Arkansas State Highway and
Transportation Department

ROUTE SLIP

AFCO STEEL

PROJECT NO.	361-105
DATE	5-20-72
BY	JERRY TAITLER
CHECKED	
APPROVED

PLAN

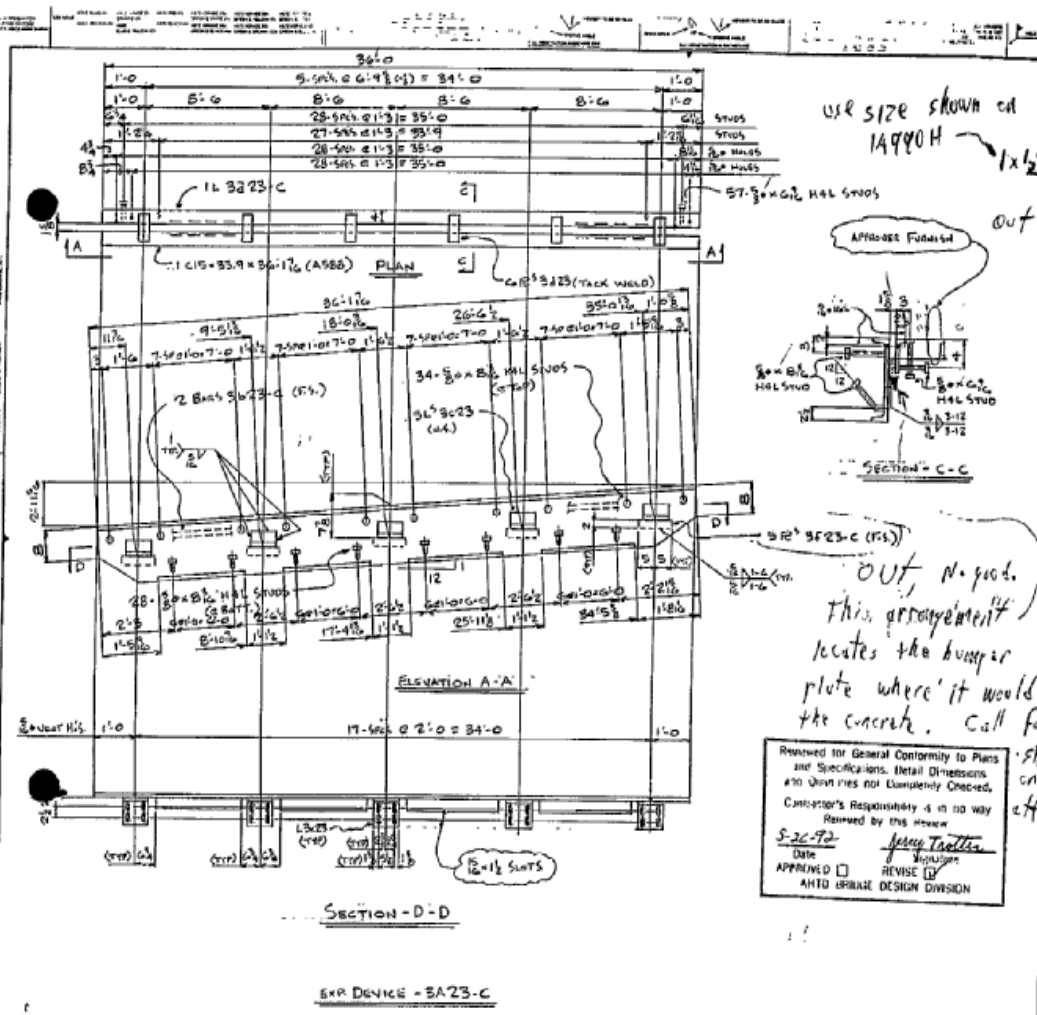
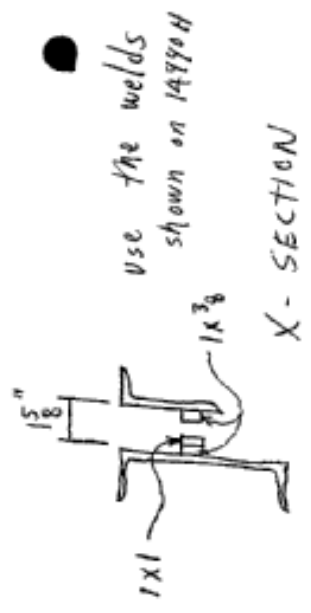
Remarks: For joints 15" or larger using a preformed joint seal, AFCO has been supplying 1x3 seal supports and separate bumper plates at each beam on one side of the joint. This system is unacceptable (by FMH) at end bents with joints 18" or larger because the separate bumper plates would bear on the concrete of the back wall rather than the embedded steel. AFCO has

USE SIZE SHOWN ON 1A990H $1 \times \frac{1}{2}$ OUT

OUT, No good. This arrangement locates the bumper plate where it would bear on the concrete. Call for the plate FOR APPROX

- 1) Supply an angle with a leg long enough to permit steel to steel bearing (a coped channel is off too)
- 2) Splice a short section of thick bumper plate at each beam into the 1x3 seal support.

SHOWN ON 1A990H OR allow cut of the two options on the left SHEET
